Historic Preservation Commission Meeting

Wednesday, July 02, 2025 at 6:00 PM

TO:	Historic Preservation Commission (HPC)
FROM:	Charlotte Moore, Principal Planner
RE:	Revised Plans for 15 Meriwether Court (COFA-01-25-019522)
DATE:	July 2, 2025

ATTACHMENT 9 PLAN REVIEW COMMENTS FOR COFA-01-25-019522

SHEET TITLE: DETAILS

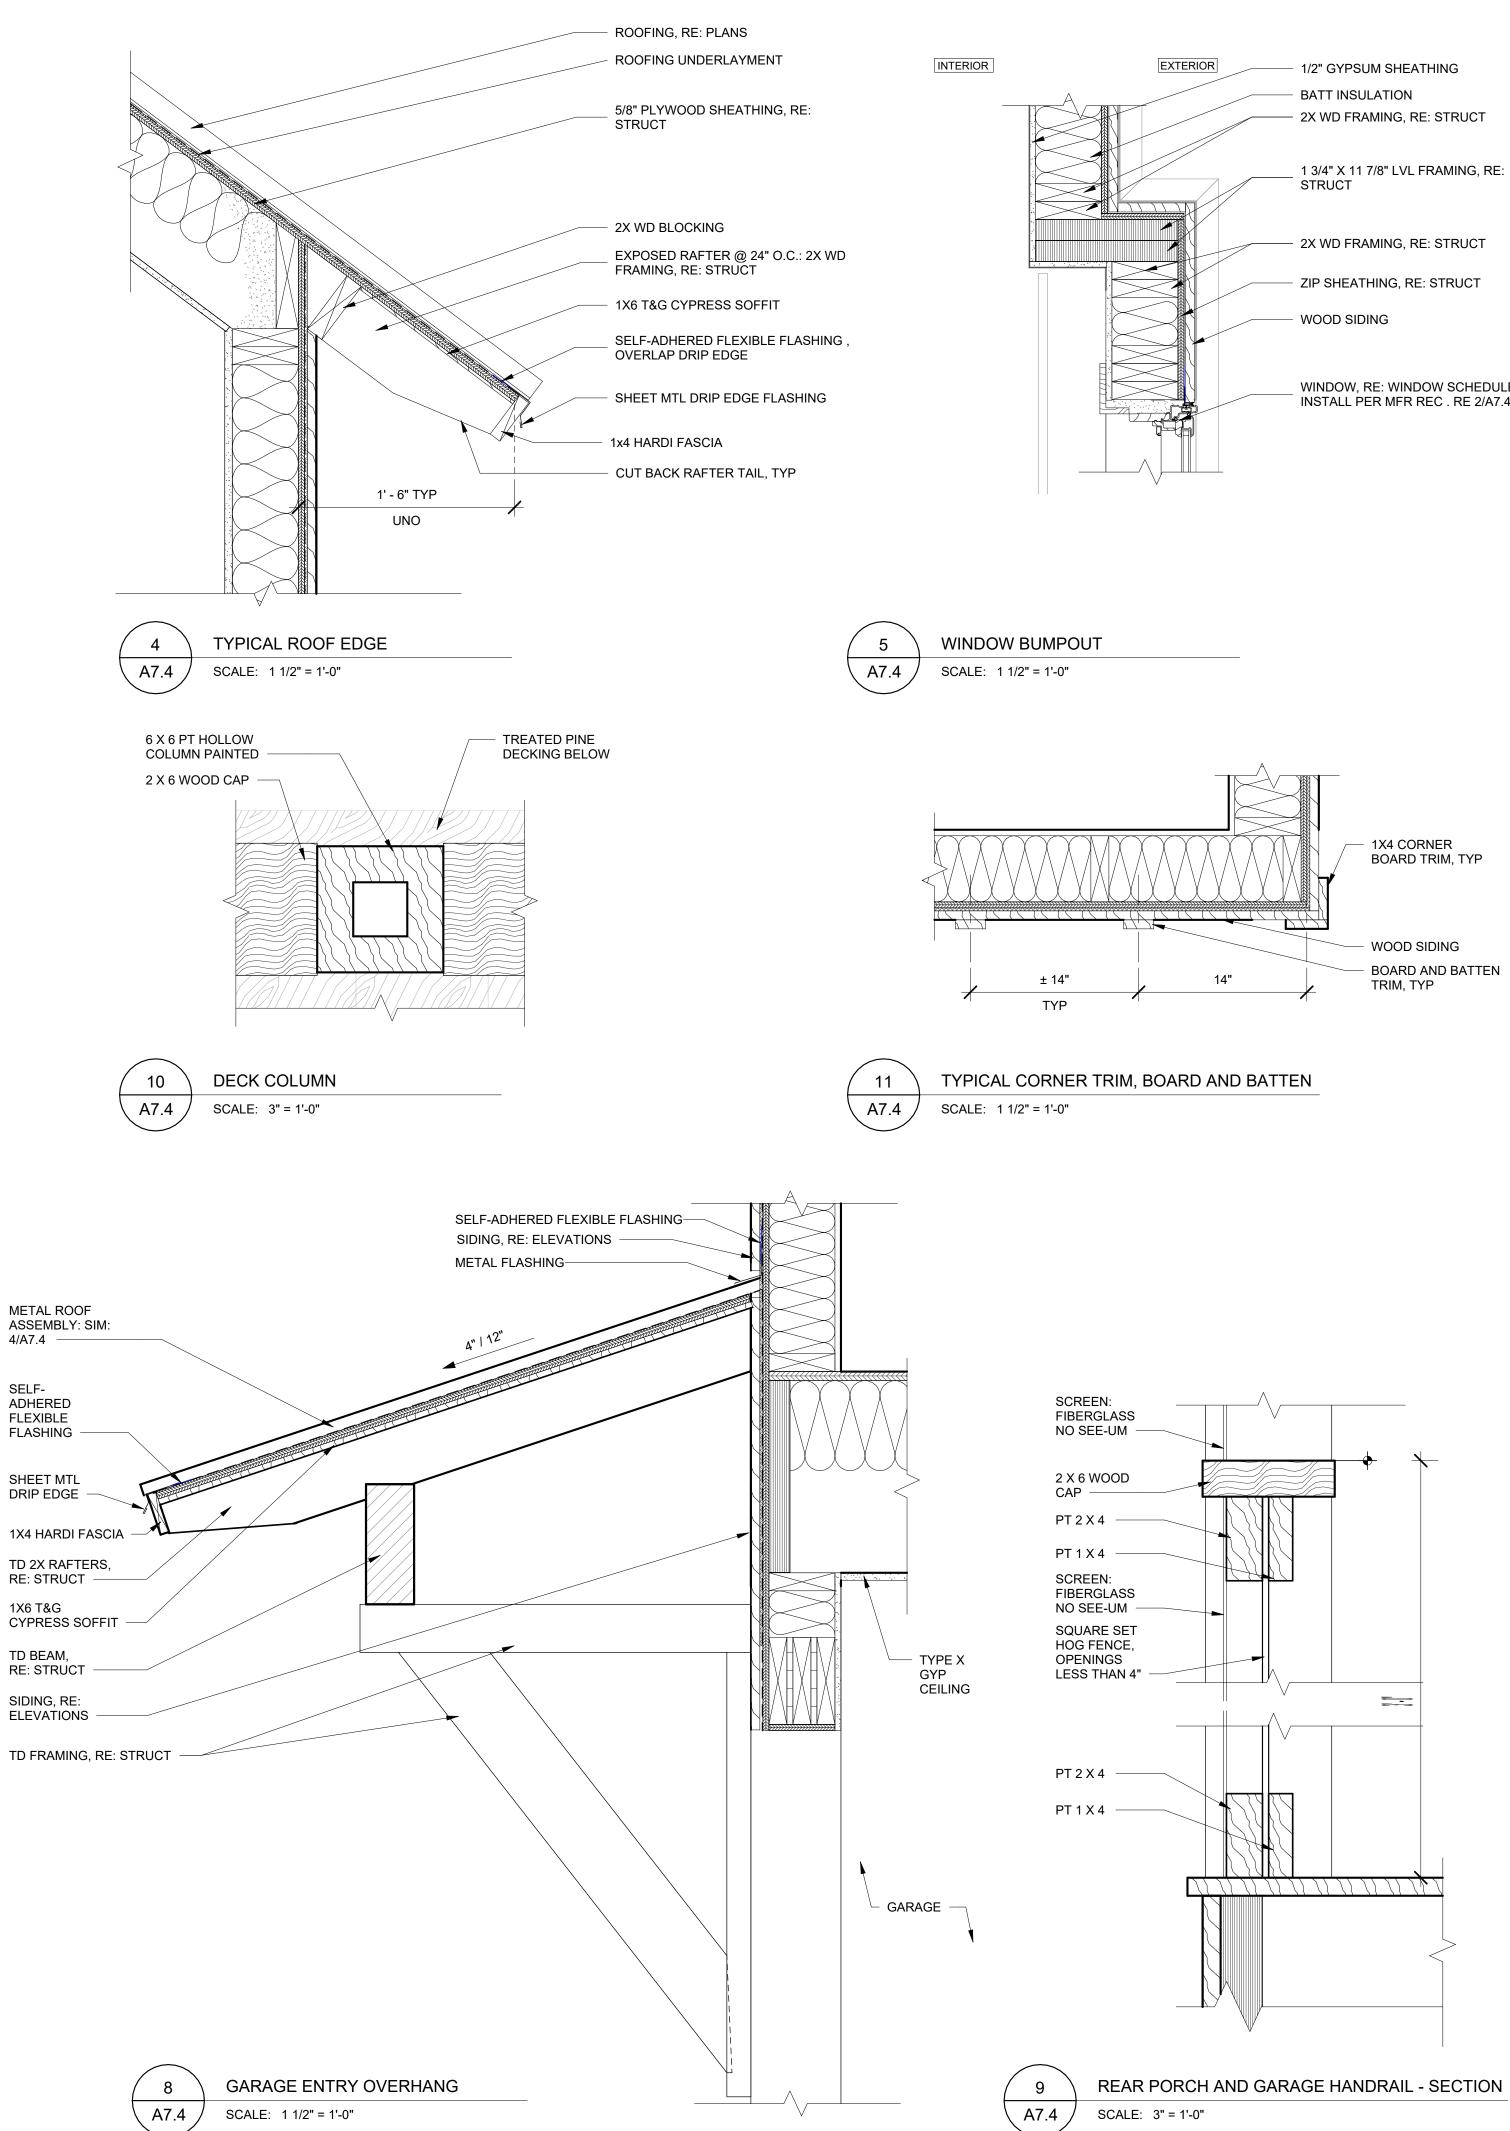
- 5. Provide corner board and water table details (UDO Sec. 5.15.6.N). The corner board is called out as 1x8 Hardie on the project analysis sheet but as 1x4 in the corner board detail (11|A7.4) and does not include the material. The correct dimension and material must be shown on the Final Plan. The water table is provided in detail 7(A7.4).

- 7. Provide a detail to show that the louvered skirting is a minimum of one-inch behind the face of each pier (UDO Sec. 5.15.6.O). Compliance is shown in detail 7(A7.4).

SHEET TITLE: SCHEDULES

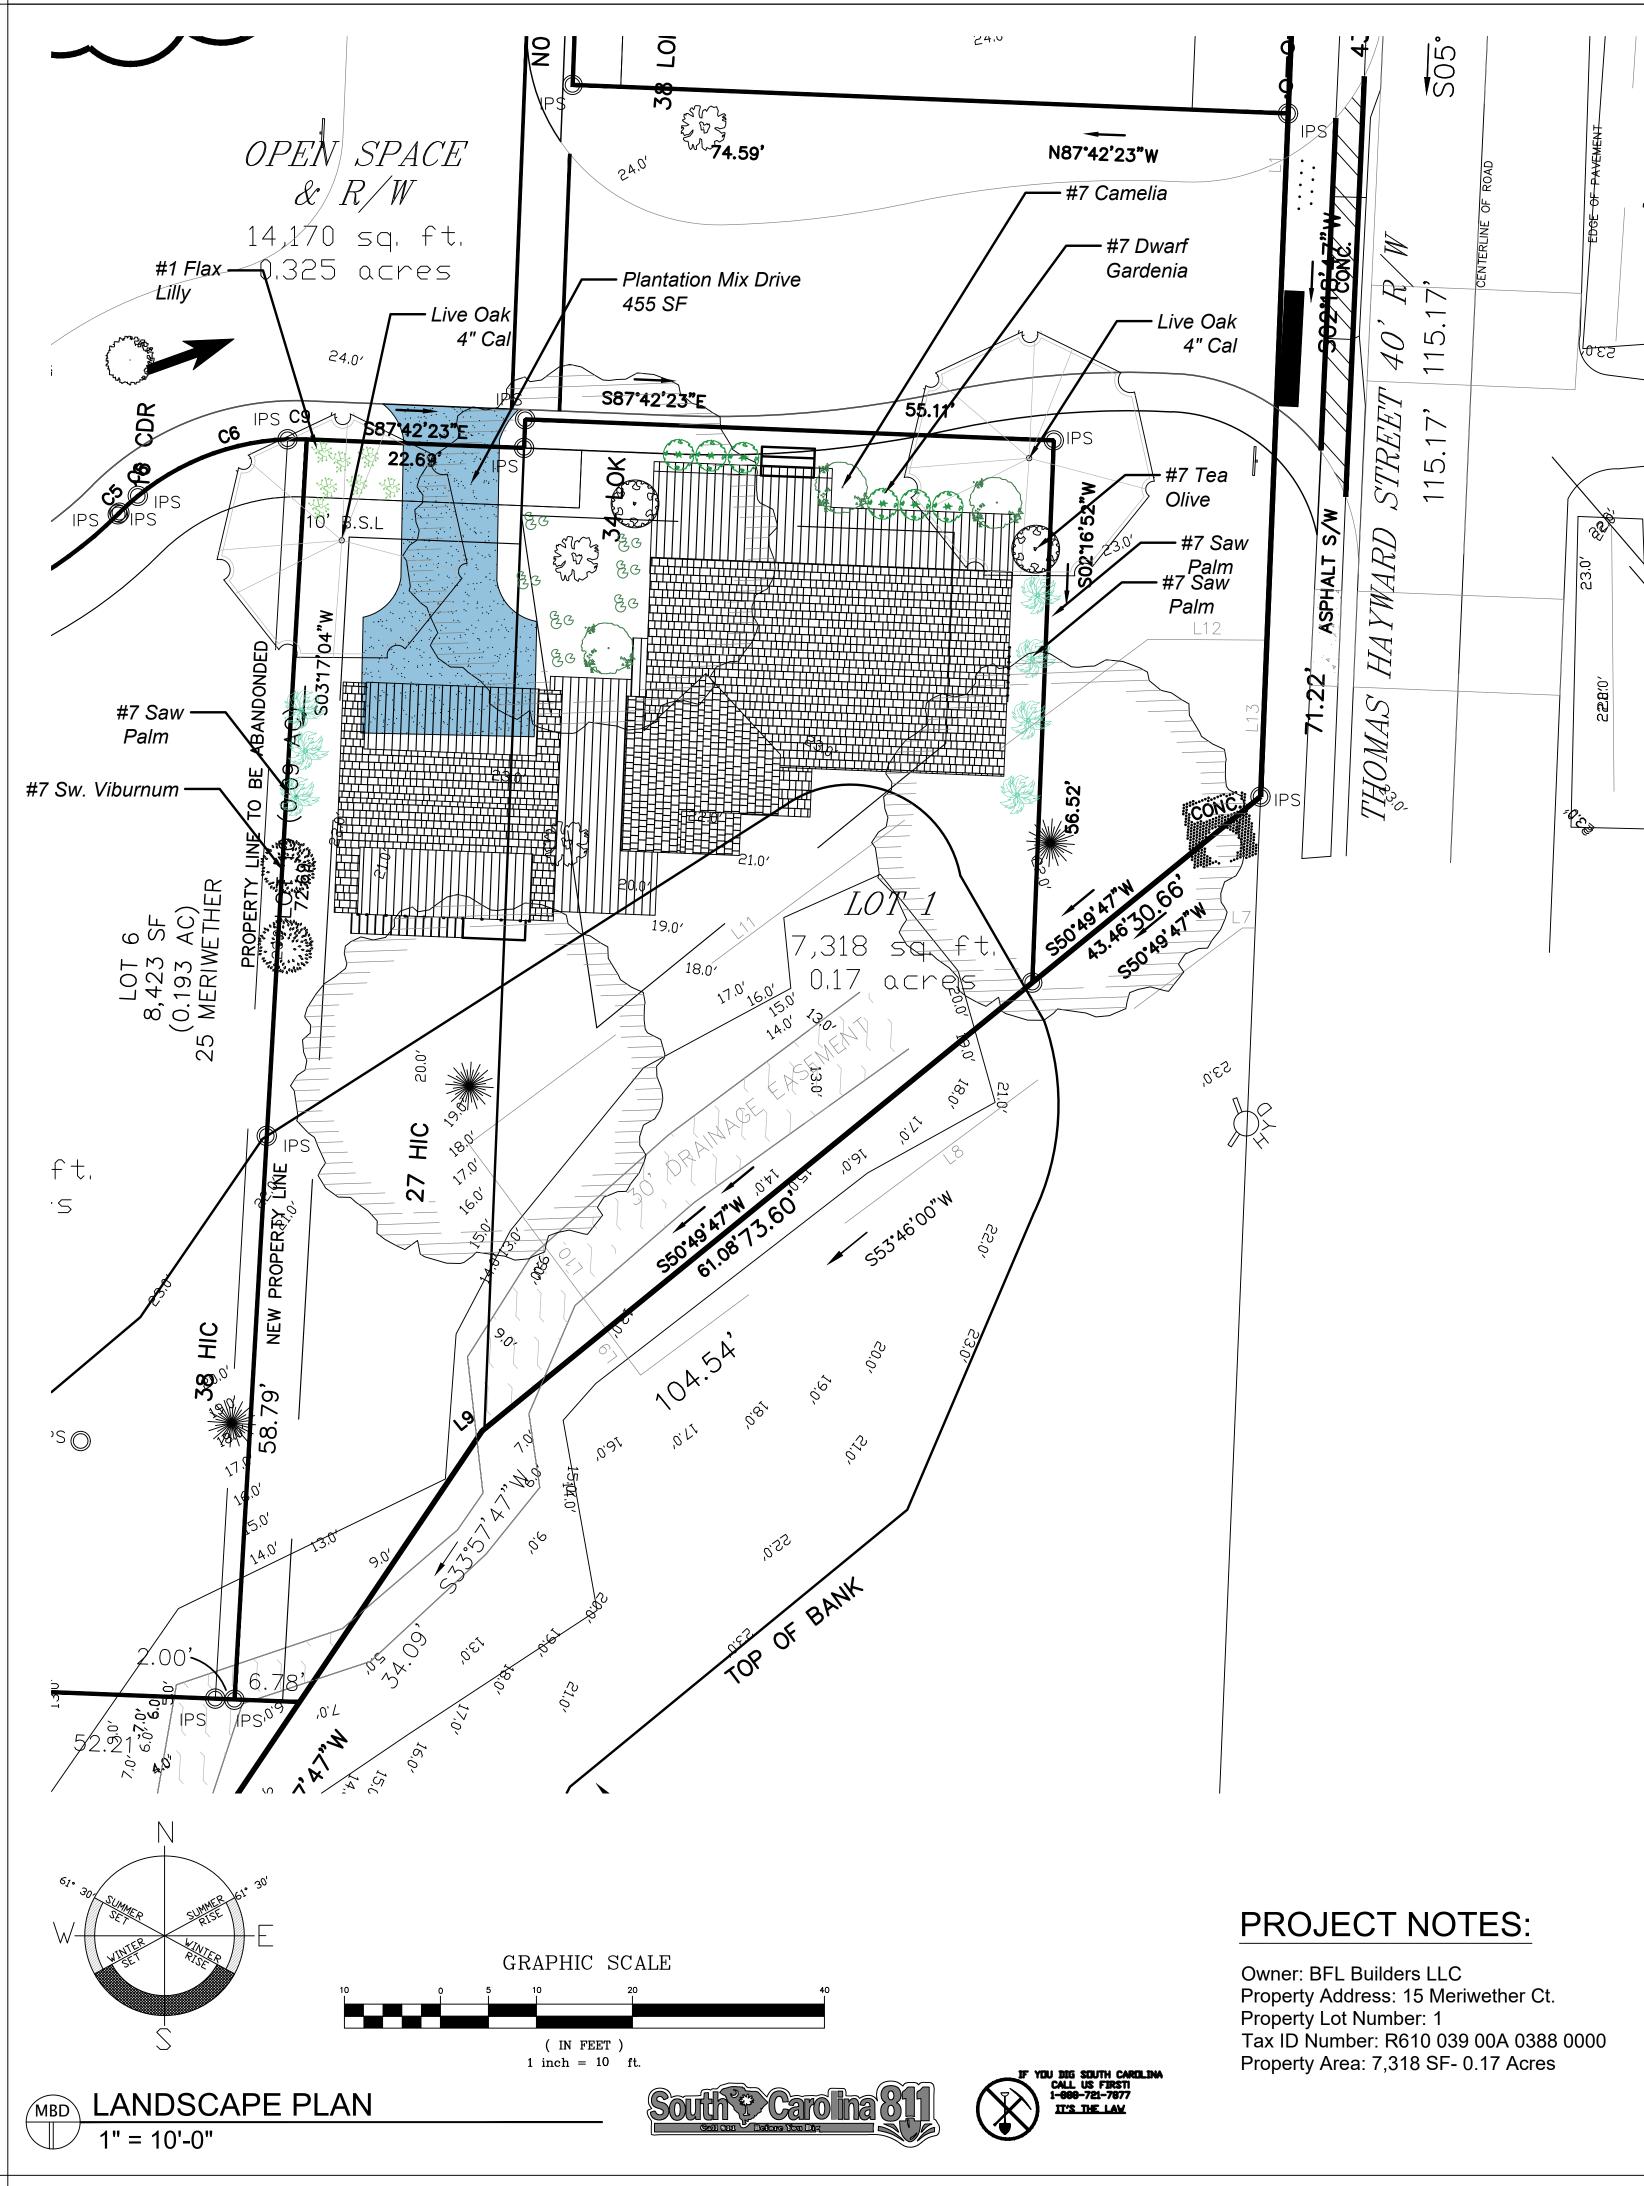
It must be noted that some doors have changed since the June HPC meeting. On the Carriage House, doors have changed from solid doors to half-panel doors. Doors identified as 120C and 220 will be wood; the material for the door identified as 120D is not identified. On the main house, the material for patio door identified as 102A is not identified and must be included in the Final Plan.
